Baffront
LBK
Rec Center

RE: LBK Rec. Center

TOWN OF LONGBOAT KEY BAYFRONT PARK RECREATIONAL CENTER 4052 GULF OF MEXICO DR LONGBOAT KEY FL 34228	CONCEPTUAL DRAWINGS GROUND FLOOR FLOOD PROOFING	REVISIONS June 17 1999 August 5 1999	SHEET 15

REQUEST FOR PLANS REVIEW

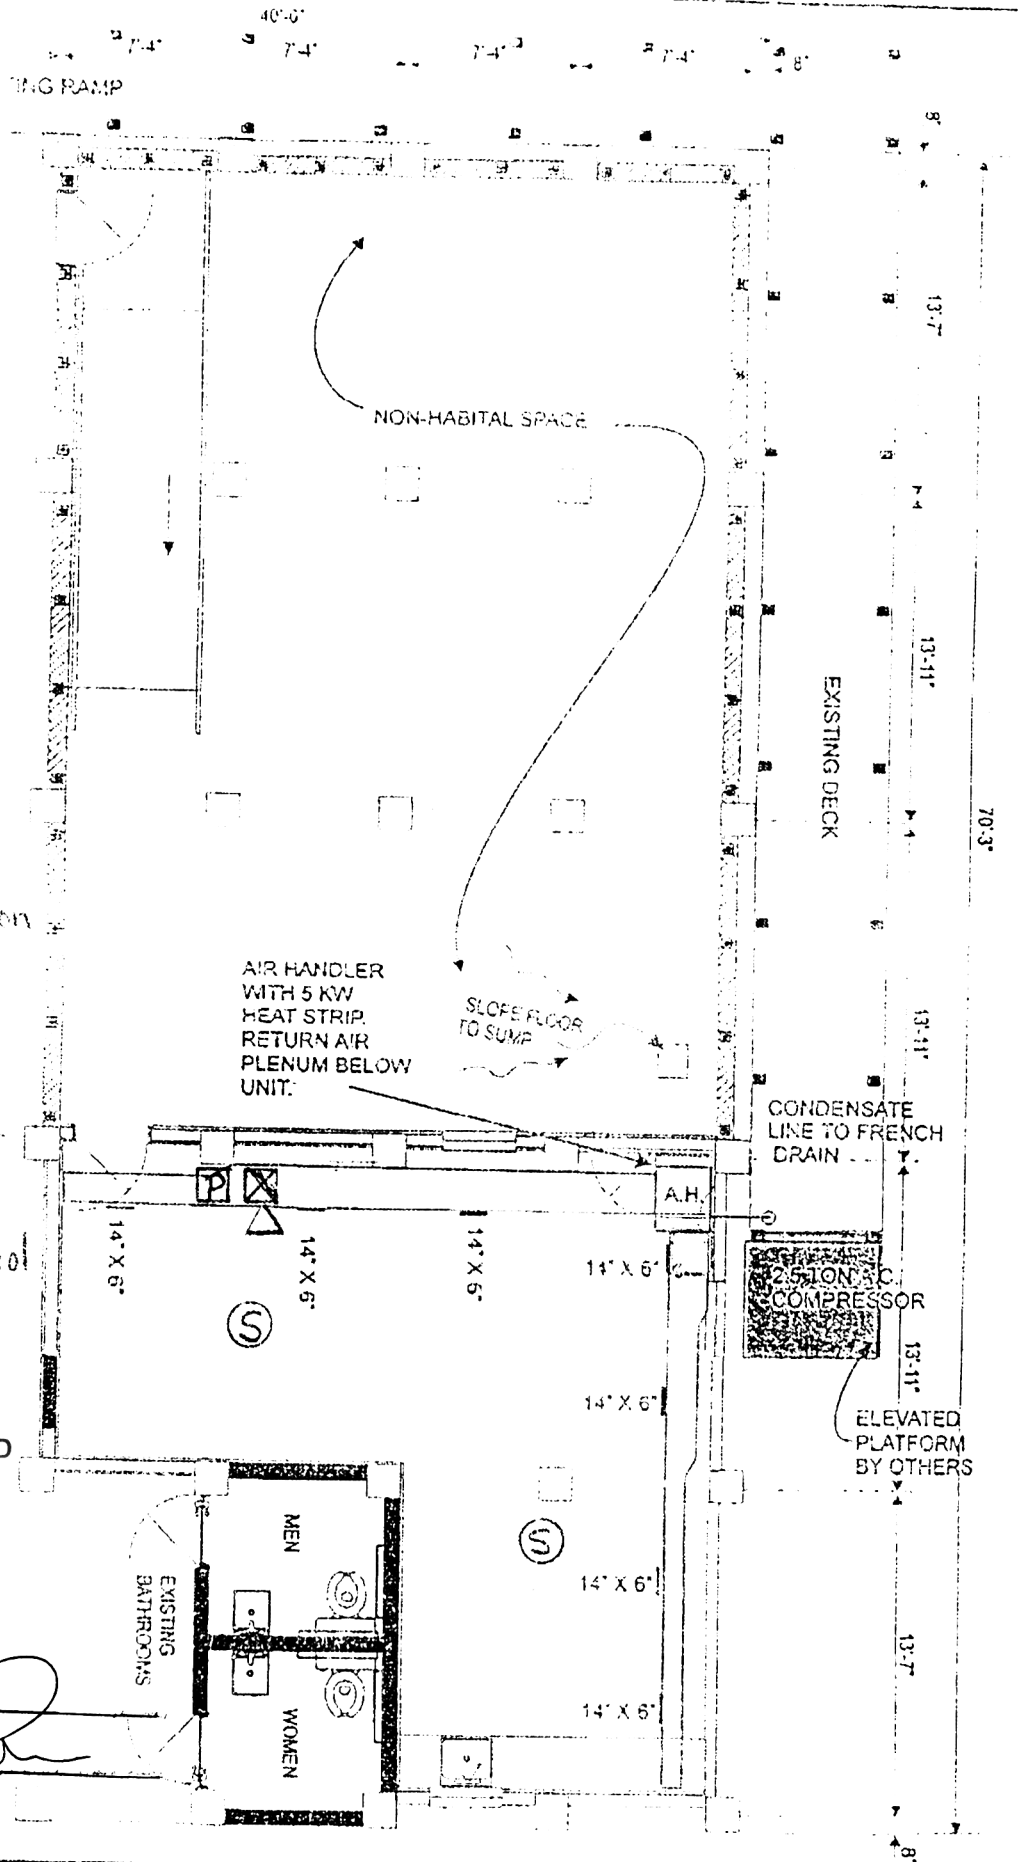
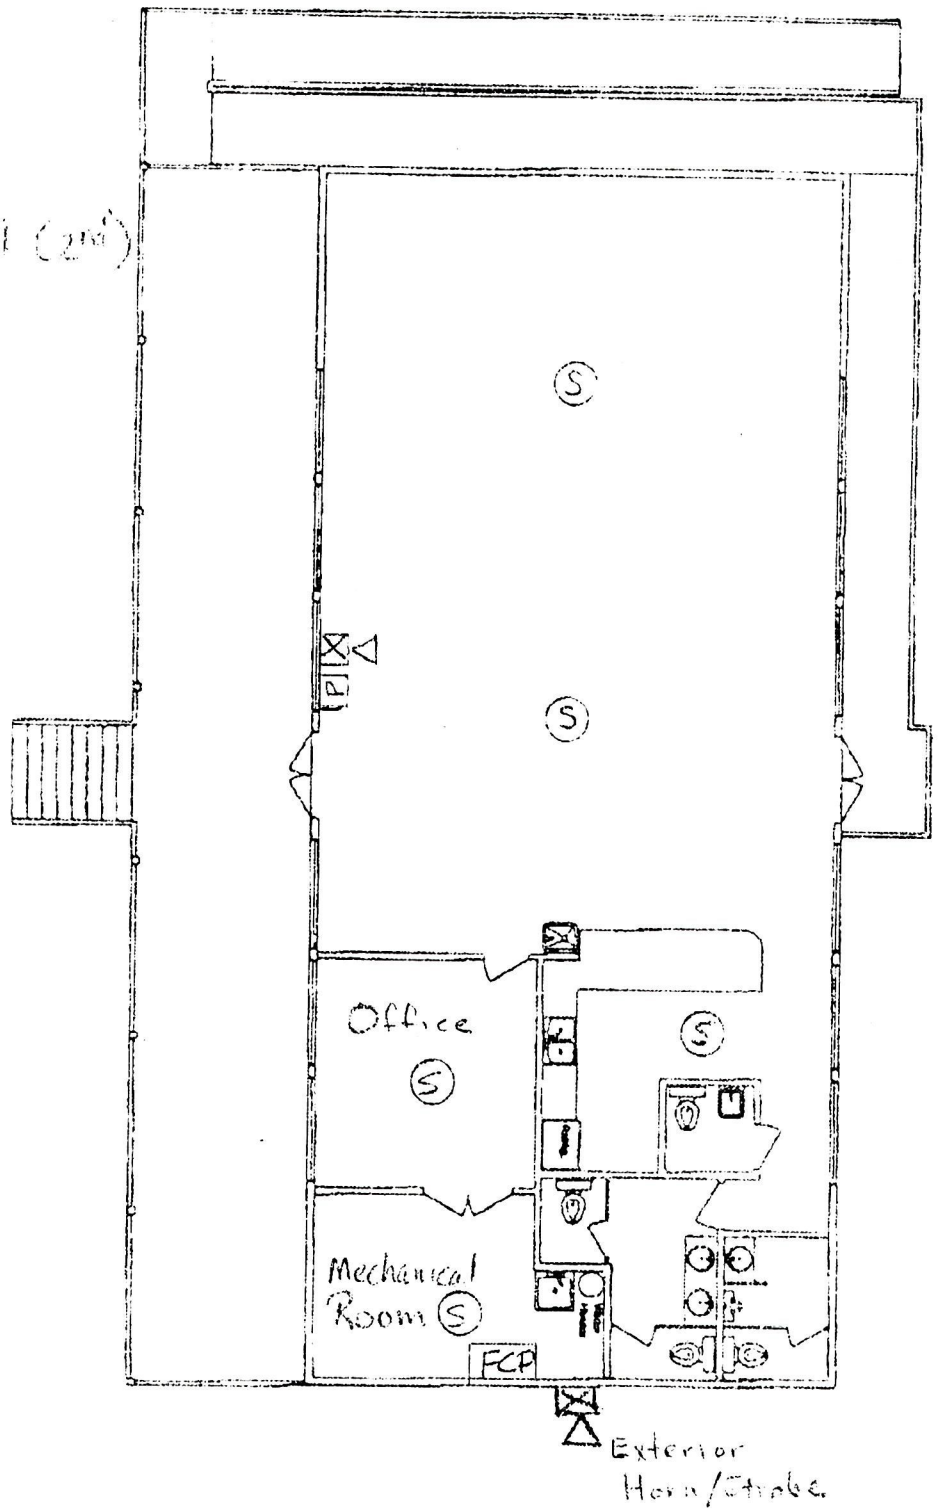
James Linkogle, with the LBK Public Works Dept, asked me to forward this floor plan to your attention. It's for the relocation of the Fire Alarm System at his old office, to the new LBK Recreation Center.

ACCEPTED AS SHOWN
BY: FIRE INSPECTOR
LONGBOAT KEY, FL

OF LONGBOAT KEY ONT PARK RECREATIONAL CENTER ULF OF MEXICO DR. BOAT KEY FL 34228	CONCEPTUAL DRAWINGS GROUND FLOOR FLOOD PROOFING	REVISIONS June 17 1999 August 5 1999	SHEET 15

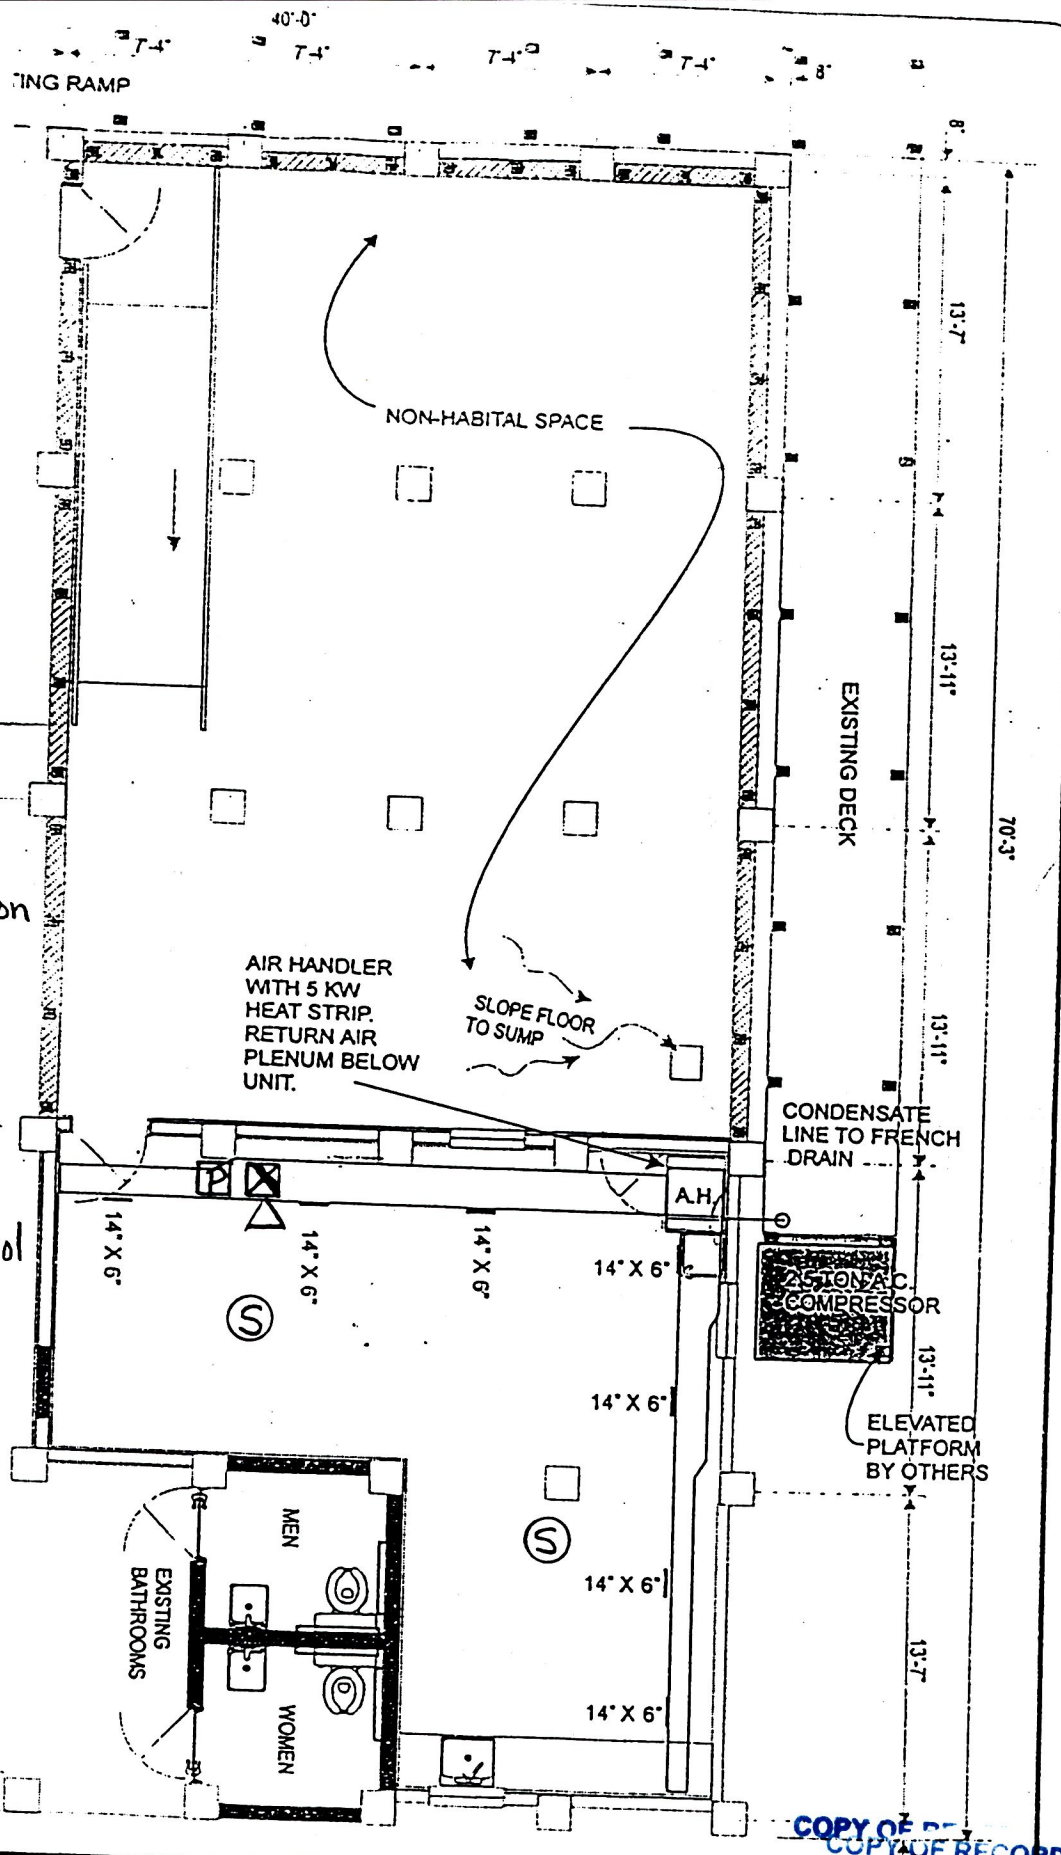
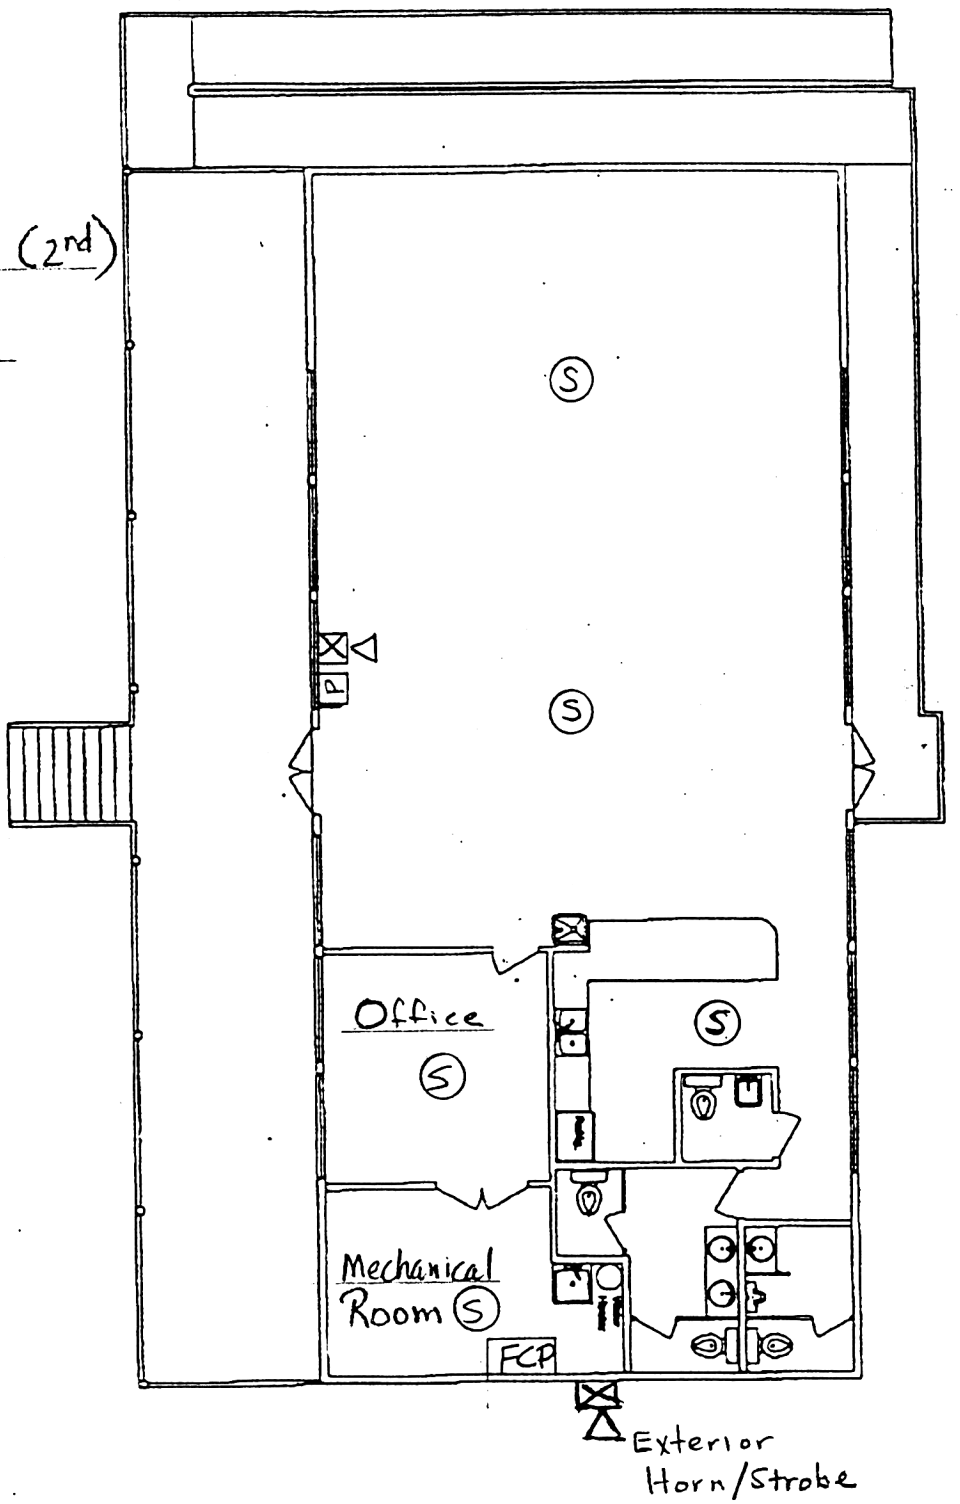
- That the existing built-in fire sprinkler system, flow alarm shall be tied into the fire alarm control panel. Pursuant to NFPA 13 & 72 & C94.46.C(1)

Plans **Accepted** as submitted:
However, Fire Final is contingent upon:

LONGBOAT RECREATION CENTER

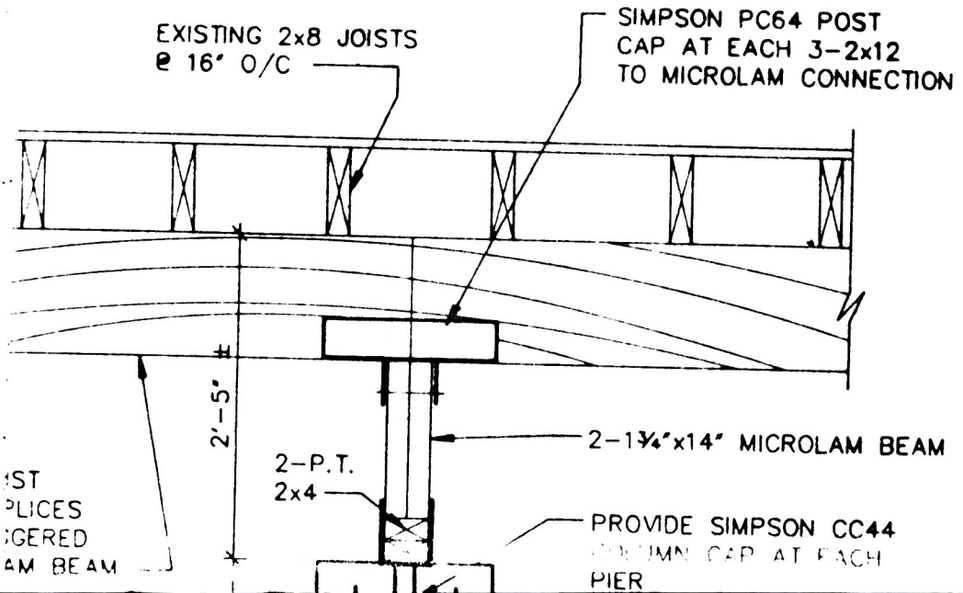
6) Foundations and first floor columns and micro-lam beams have been designed to sustain a live load of 100 psf on the first floor.

LONGBOAT RECREATION CENTER

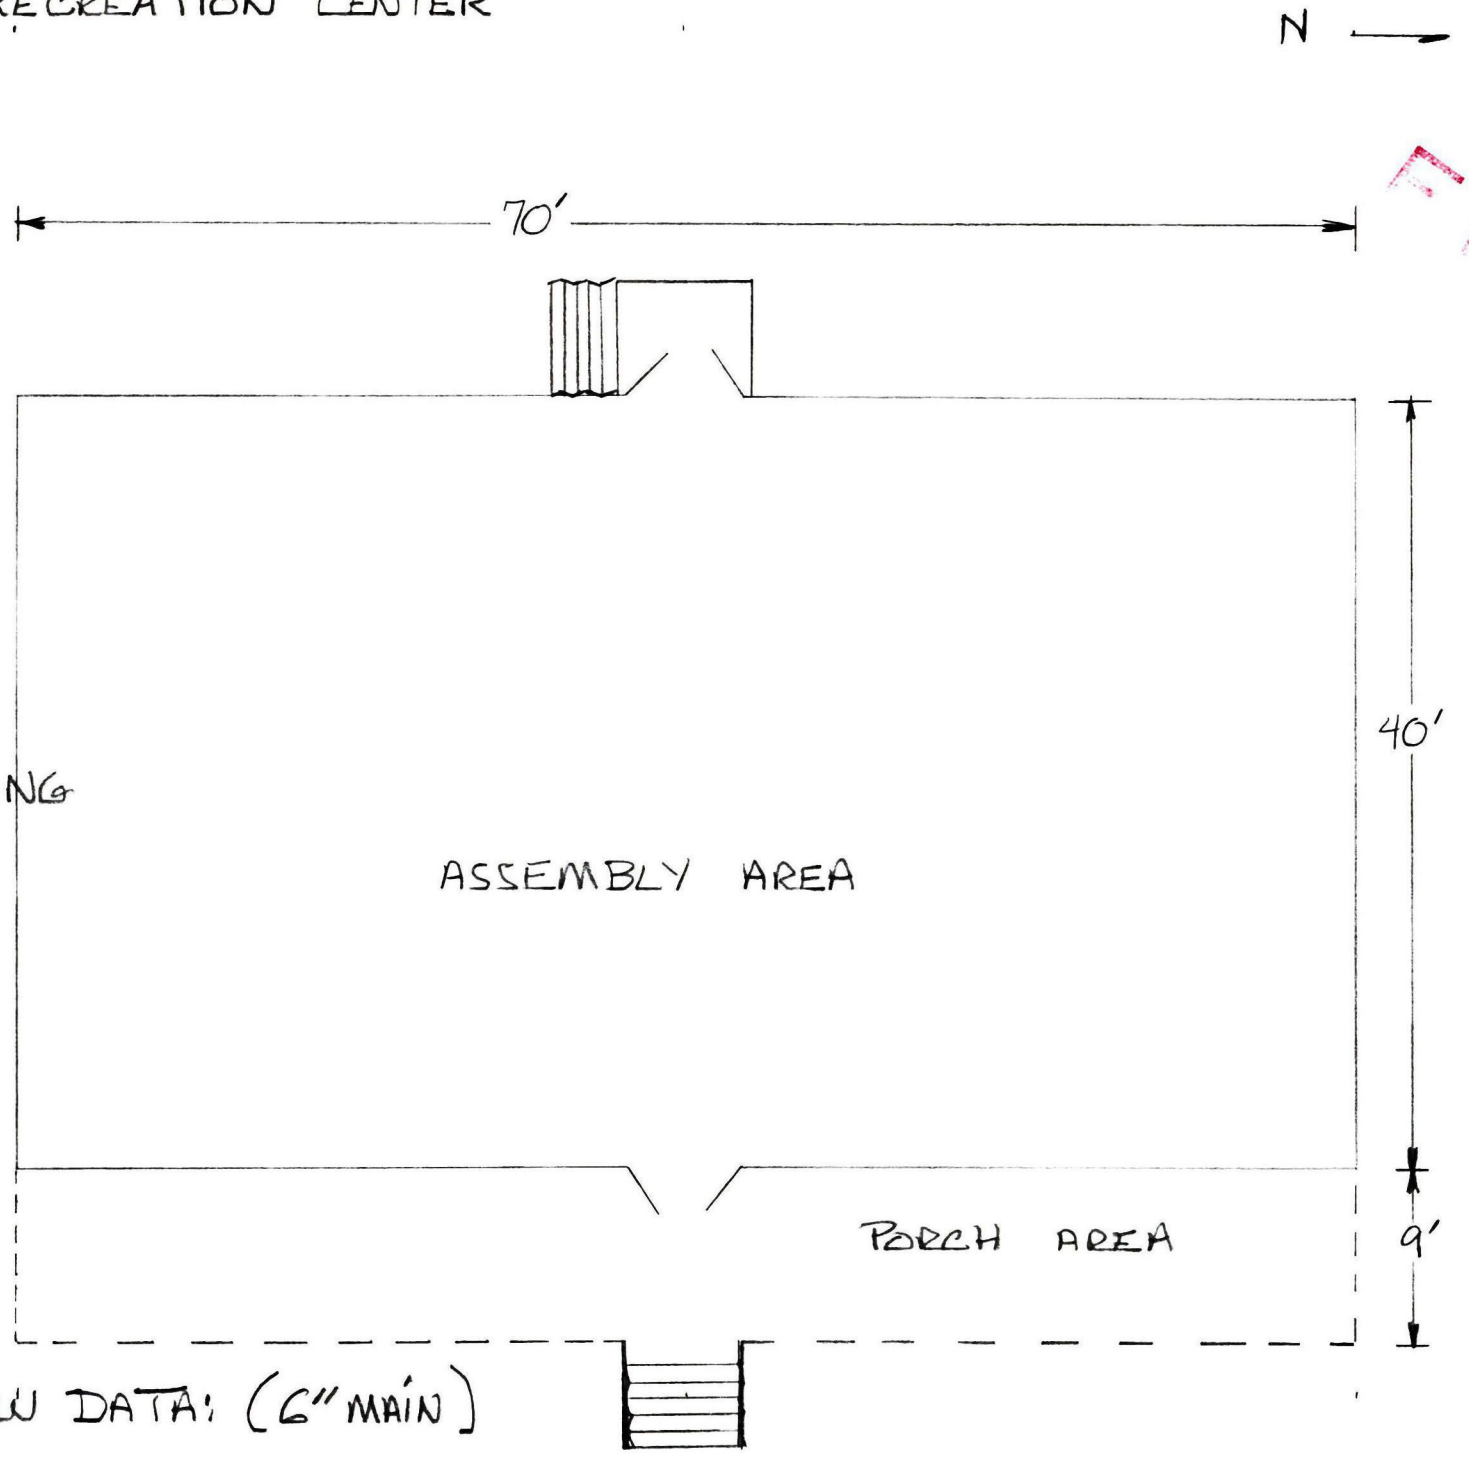
SUGGEST LOCATION

NEEDS FOUR HYDRANTS LOCATED AS SHOWN IN RED CIRCLES
